OAKS STAIRWAY & OVERLOOK PROJECT
EAST FORK, SAN GABRIEL RIVER

ADDENDUM No. 1				
ALTERNATIVE BID ITEMS				
	ITEM	PROPOSED ALTERNATIVE	CONSTRUCTION LEGEND L-2.00 & L-2.01	BID ITEM
A1	ASPHALT PAVING (CHIP SEAL SURFACE)	DEDUCT ASPHALT PAVING IN UPPER PARKING AREA AND PARALLEL PARKING ON EAST FORK ROAD, AS INDICATED ON PLAN.	18	12
A2	CONCRETE FLAT WORK (EXPOSED AGGREGATE FINISH WITH MONOLITHIC CURB)	DEDUCT PORTION OF CONCRETE FLAT WORK (EXPOSED AGGREGATE FINISH WITH MONOLITHIC CURB), AS INDICATED ON PLAN.	3	13
A3	CONCRETE WORK -GUTTER	DEDUCT PORTION OF CONCRETE WORK -GUTTER, AS INDICATED ON PLAN.	32	16
A4	MASONRY SEAT WALLS - LOCAL STONE PER DETAIL L-2.52 ND L-2.53	DEDUCT LOCAL STONE MASONRY CONSTRUCTION FOR POURED IN PLACE CONCRETE WITH "STAMPED/FORMED" STONE PATTERN, BELOW SHADE STRUCTURES AS INDICATED ON PLAN.	47	28
A5	OPTIONAL EAST SHADE TRELLIS STRUCTURE - WEATHERING STEEL FRAMES AND STRUCTUAL FOOTINGS AND UNDERNEATH SEAT WALLS.	OPTIONAL CUSTOM SHADE TRELLIS STRUCTURE AND COLUMN SEATWALLS AS INDICATED ON PLAN.	33	34

TITLE SHEET

JULY 15 2026

TS-00

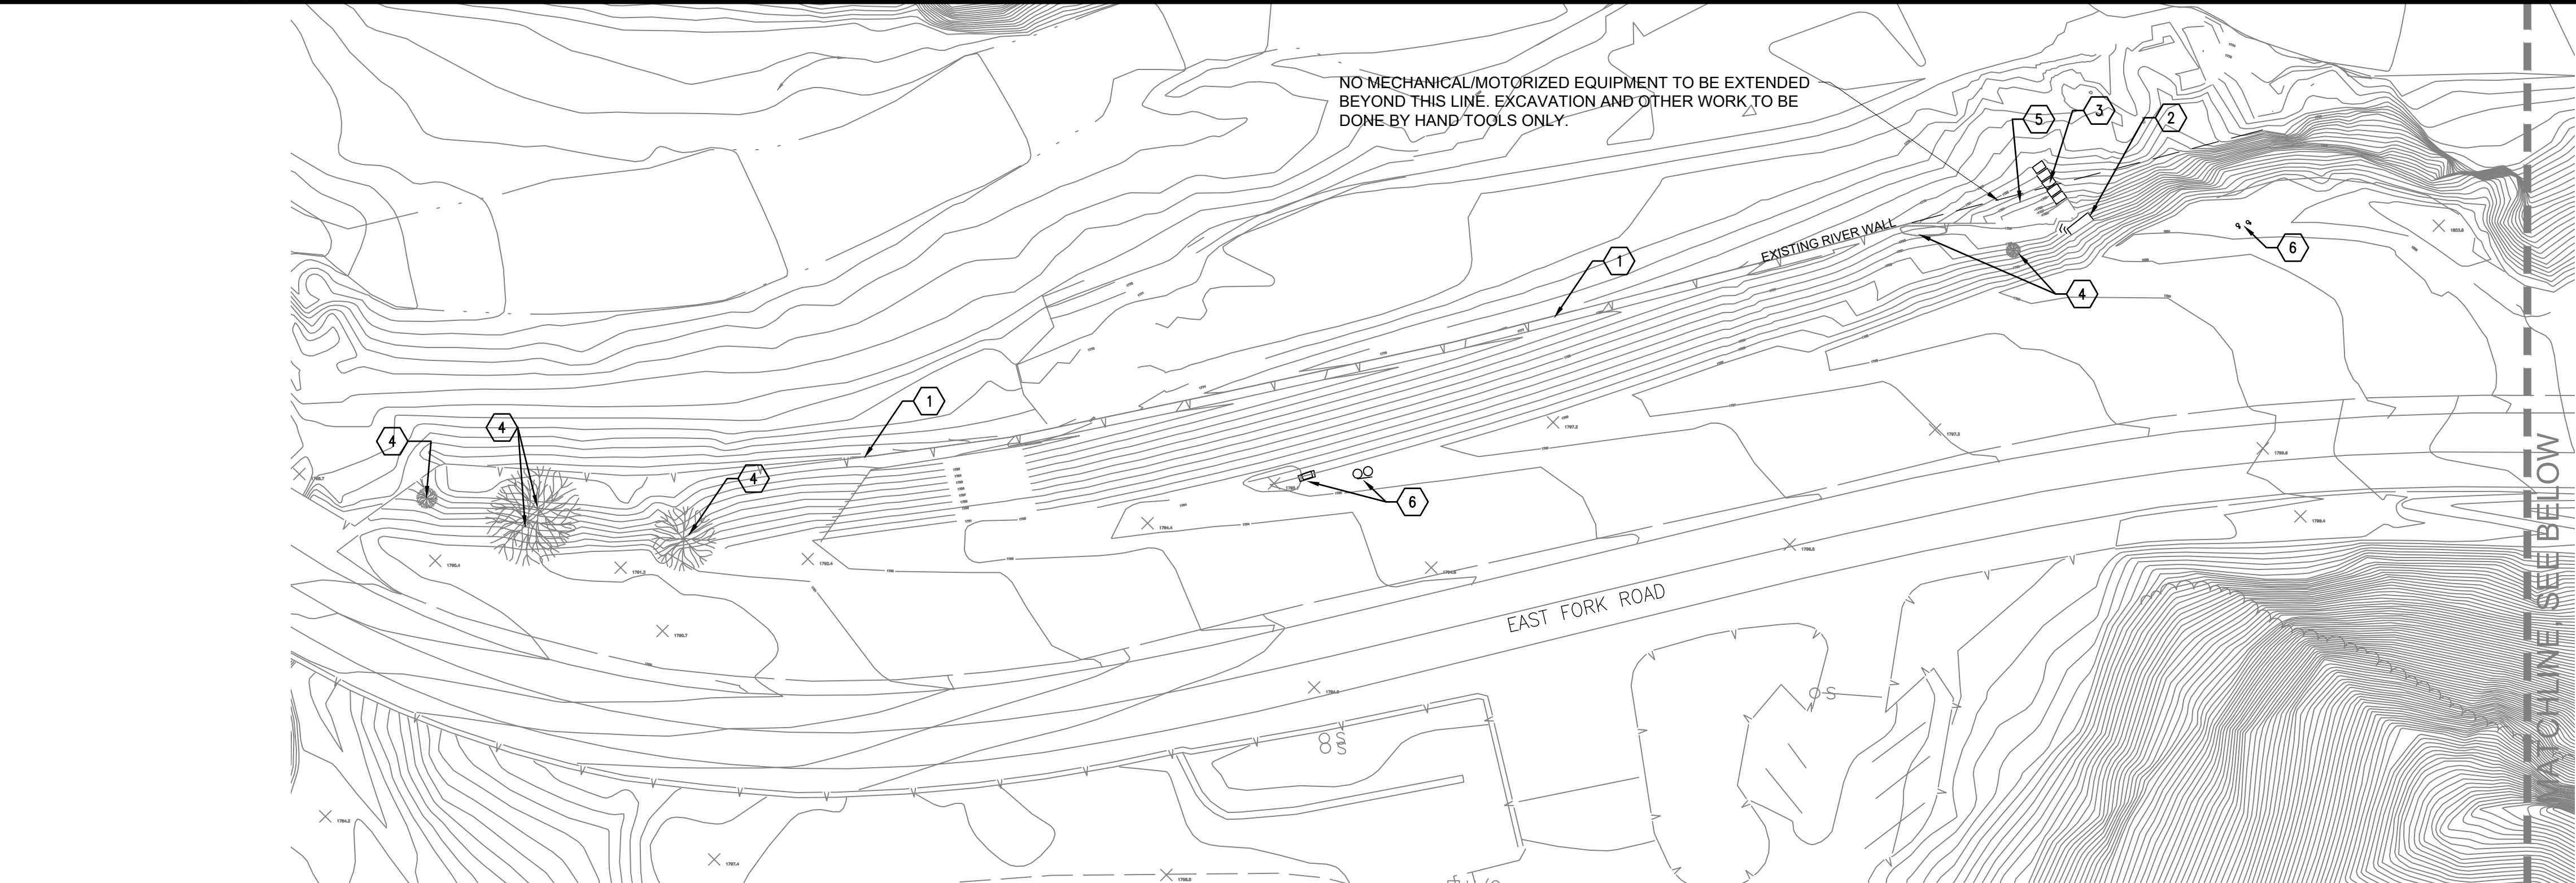
A6	REVISE SHADE STRUCTURES	SUBSTITUTE CUSTOM SHADE TRELLIS STRUCTURES FOR POLYGON MONOSLOPE, COMPLETE INSTALL, DEDUCT EAST STRUCTURE, AS INDICATED ON PLAN.	33	34
A7	SITE FURNISHINGS	DEDUCT TWO PICNIC TABLES BELOW EAST SHADE STRUCTURE, AS INDICATED ON PLAN.	11	40
A8	STRIPING AND PAVEMENT MARKINGS	DEDUCT STRIPING AND PAVEMENT MARKINGS - PARKING SPACES, ADA STALLS, CROSSWALKS, AND PARALLEL PARKING ALONG FORK ROAD, IN UPPER PROJECT AREA, AS INDICATED ON PLAN.	15	46
A9-13	PLANTING, IRRIGATION, ESTABLISHMENT, AND MAINTENANCE PERIOD SOIL AMENDMENT / PLANTING PREP, 1 & 5 GALLON CONTAINER PLANT	DEDUCT PLANTINGS AS INDICATED ON PLAN.	SEE L-4.50	
A14	HYDROSEED	DEDUCT HYDROSEED AS INDICATED ON PLAN.	SEE L-4.50	
A15	STONE BARRIER WALLS AT OVERLOOK - NATURAL STONE PER DETAIL SHEET L-2.52/L-2.53	CONSTRUCT STONE BARRIER WALLS, SEAT WALLS, AND MASONRY BENCHES USING NATURAL ROCK.	1	25
PLAN REVISIONS				
THE FOLLOWING CHANGES ARE INCLUDED IN PLAN DOCUMENTS DATED JUNE 2026

MASONRY BARRIER WALLS AT OVERLOOK - STAMPED CONCRETE	SUBSTITUTE USING LOCAL STONE MASONRY CONSTRUCTION FOR POURED IN PLACE CONCRETE WITH "STAMPED/FORMED" STONE PATTERN, PER SHEET W-1.00.	1	25
	2-YARD DUMPSTER	DEDUCT 2-YARD DUMPSTER	14	N/A
	WALL-MOUNTED DOG WASTE BAG DISPENSER	DEDUCT WALL-MOUNTED DOG WASTE BAG DISPENSER	42	N/A
	SPLIT RAIL FENCE	DEDUCT SPLIT RAIL FENCE	13	N/A
	BAG DISPENSER SIGNAGE	DEDUCT BAG DISPENSER SIGNAGE	42	N/A
	PREFAB RESTROOM	SUBSTITUTE 4 TOILET ROMTEC TO BE CXT 2 TOILET UNITS	17	32
